# **Planning Commission Meeting Packet**

**July 12, 2016**

COVER MEMO  
**SP 16-04**  
**Sherwood Plaza Apartments**

**To:** Planning Commission  
**From:** Michelle Miller, AICP Senior Planner  
**RE:** SP 16-04 Sherwood Plaza Materials for July 12, 2016 continued Hearing  
**Date:** July 5, 2016

Exhibit J

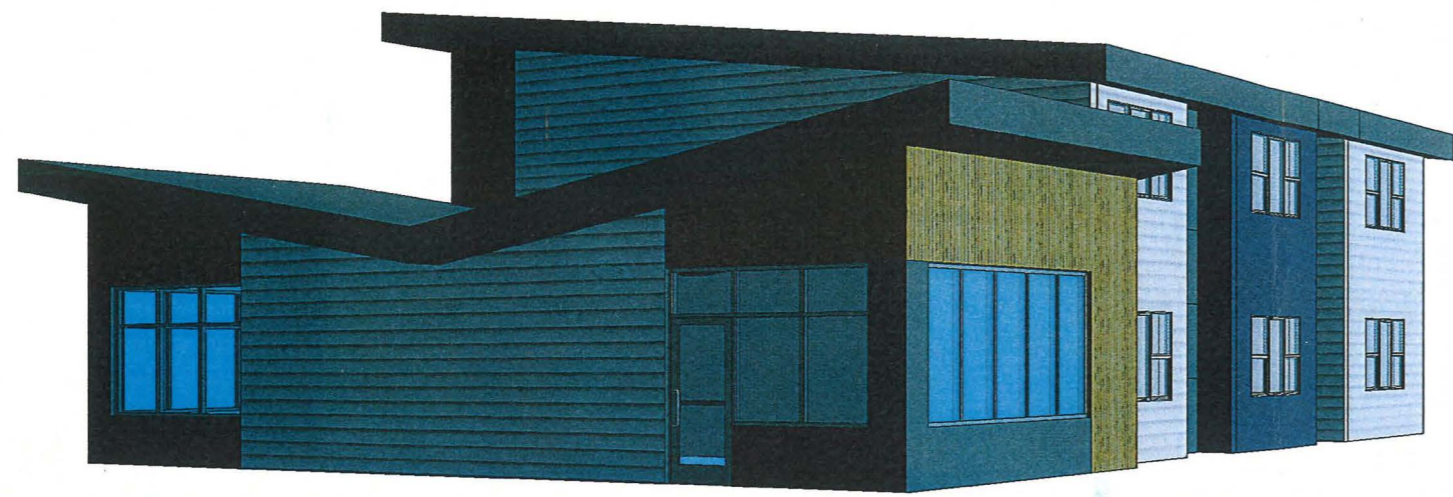
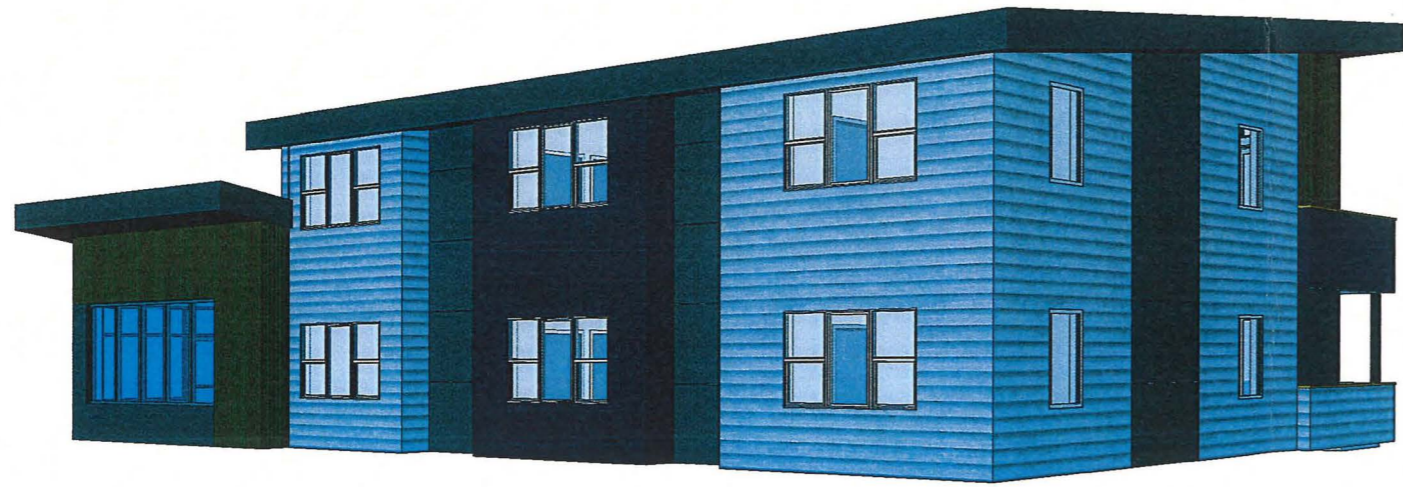
The other building using the front yard setback of SW Langer Drive to the north, "Building A" has a side elevation that directly faces northern SW Langer Drive, with a 28 foot setback. Building 1 and 2 are flush with SW Langer Drive on the north and need to be oriented to the street. The applicant shows a side elevation at this location rather than a front elevation for Building 2, with limited articulation and orientation to the pedestrian. The applicant will need to revise this elevation in order to meet the intention of this standard.

**RECOMMENDED CONDITION:** Prior to final site plan approval, provide revised elevations for the northern sides of Building ~~s-1 and-2~~ which front SW Langer Drive. The elevations shall clearly demonstrate how the ~~buildings-building are-is~~ located and oriented to the street, and ~~have-has~~ significant articulation and treatment, via facades, sidewalk connection, porticos, arcades, porches, portal, forecourt, or stoop to identify the entrance for pedestrians.

**Revised Building 1 Elevation facing SW  
Langer**

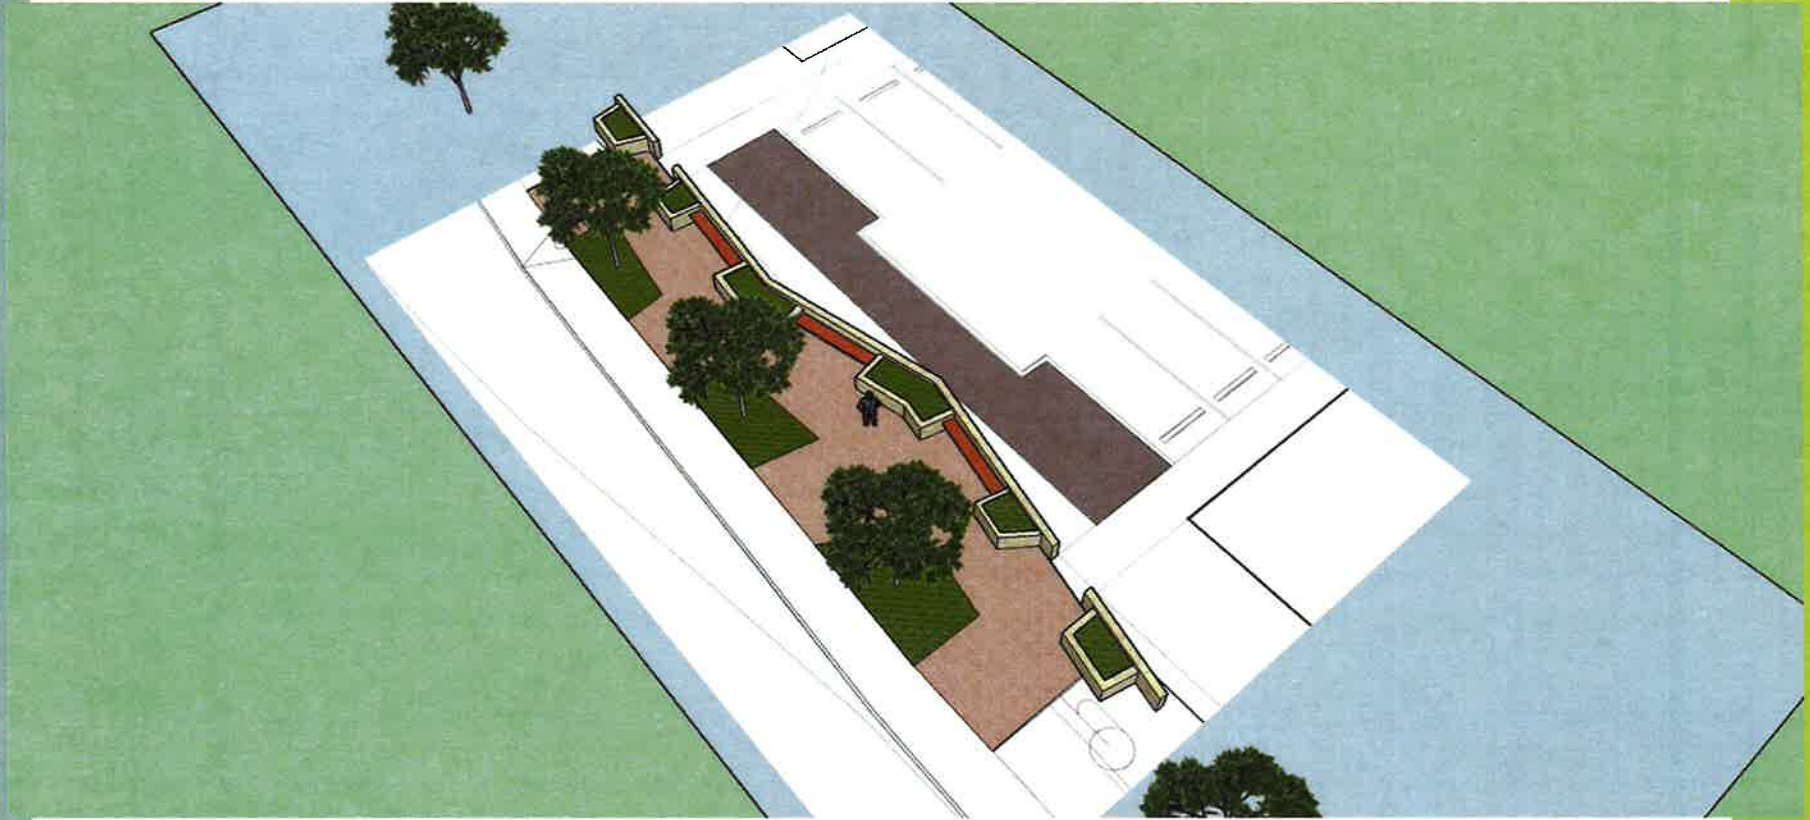
**Planning Commission Discussion:** The applicant submitted additional information on addressing this criterion. (Exhibit I). The applicant proposes a pedestrian plaza with additional streetscape amenities along the frontage of the apartment complex portion of SW Langer Drive. These include a different colored sidewalk treatment, trees, benches, and concrete planter boxes and a short wall. This will bring activity to the front of the area and will break up the building façade on the street facing elevation.

The applicant noted in their testimony that the street facing elevation of building 1 had different fenestration, but was not shown on the submitted plans. The additional design elements satisfy the condition with respect to building 1.
